From: Shannon McIntyre
City of Mobile Architectural Engineering Department

Re: Mims Park – Athletic Restrooms and Concessions

Project #PR-048-24B

Date: November 12, 2024

01 HARDSCAPE ENLARGEMENT & LAYOUT (ALTERNATE)
1" = 10'-0"

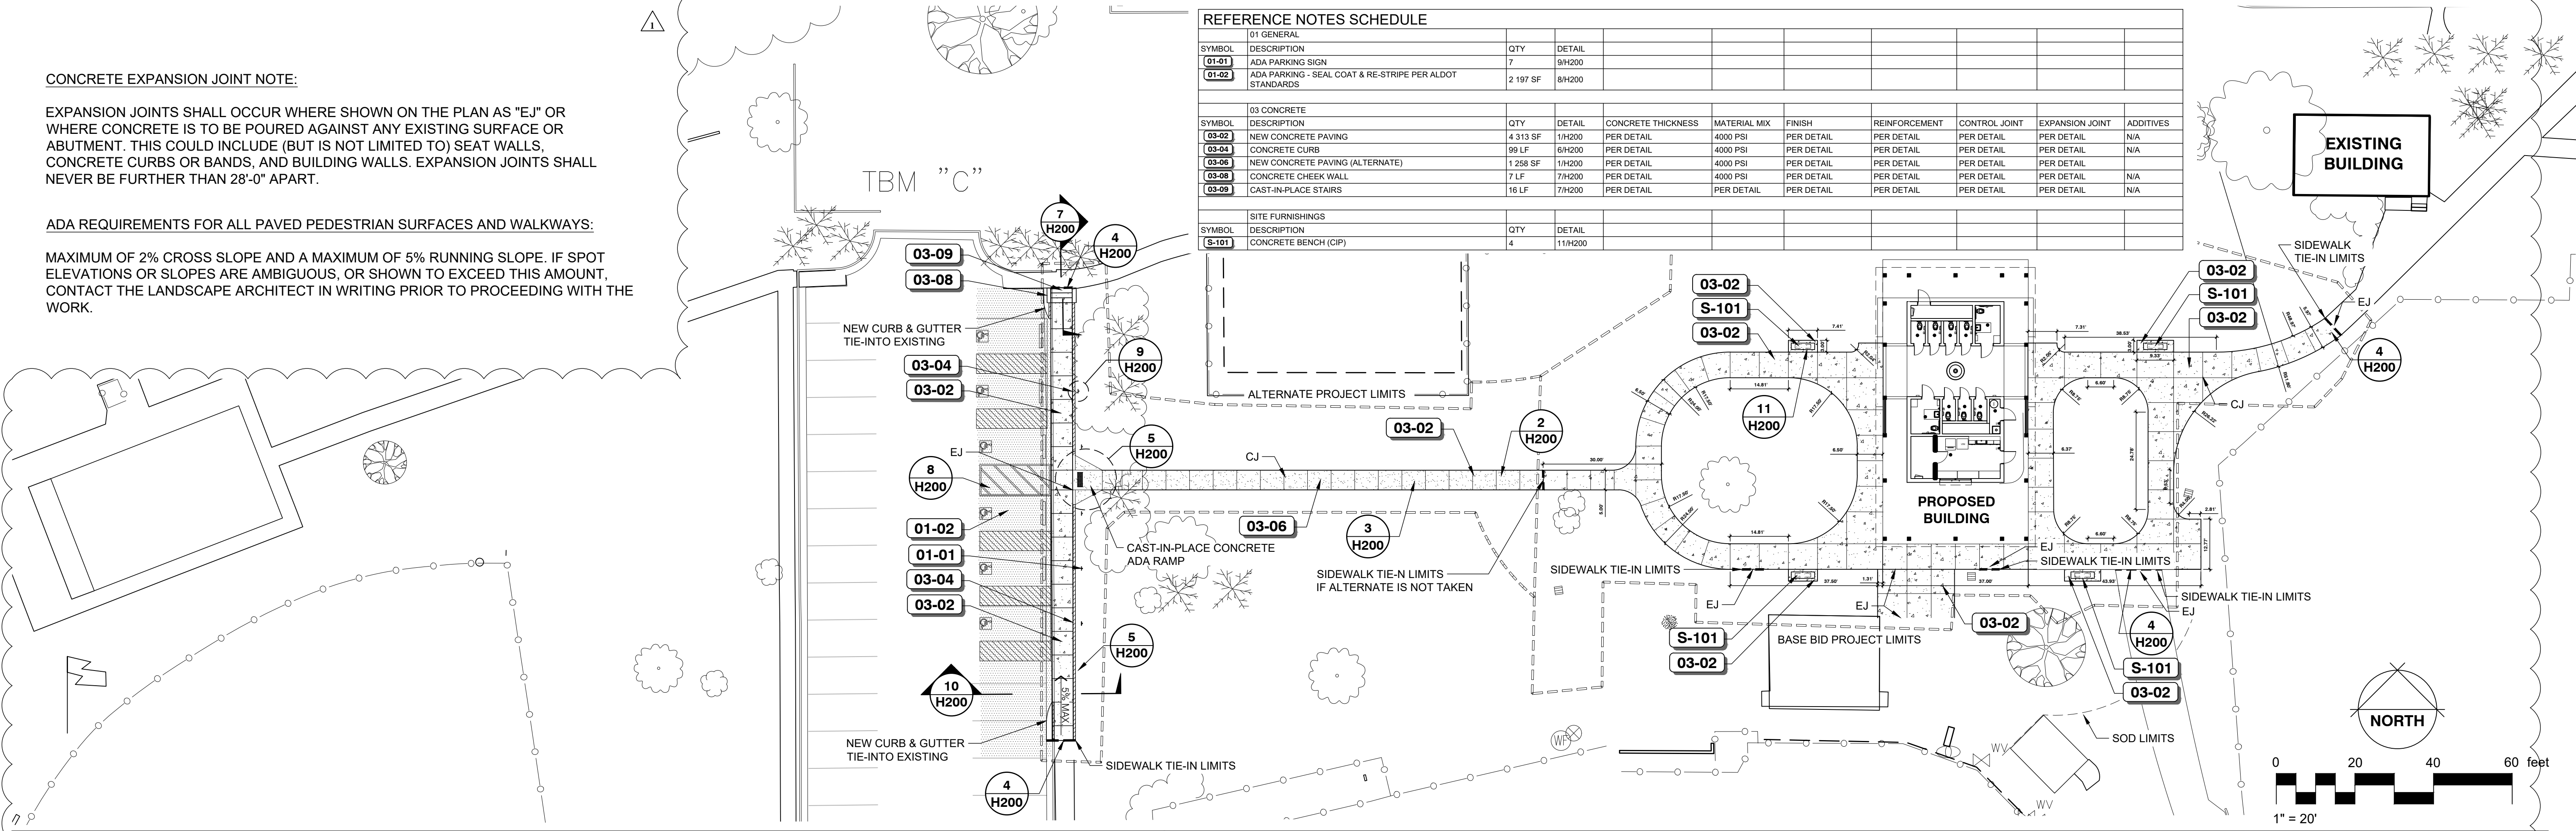
The scale on C3.0 appears to be correct. The alternate concrete sidewalk would be 1,263 SF. H100 Detail #1 Alternate is showing 886 SF of sidewalk alternate.

A: Reference Addendum 4 Sheet H100 for updated quantities
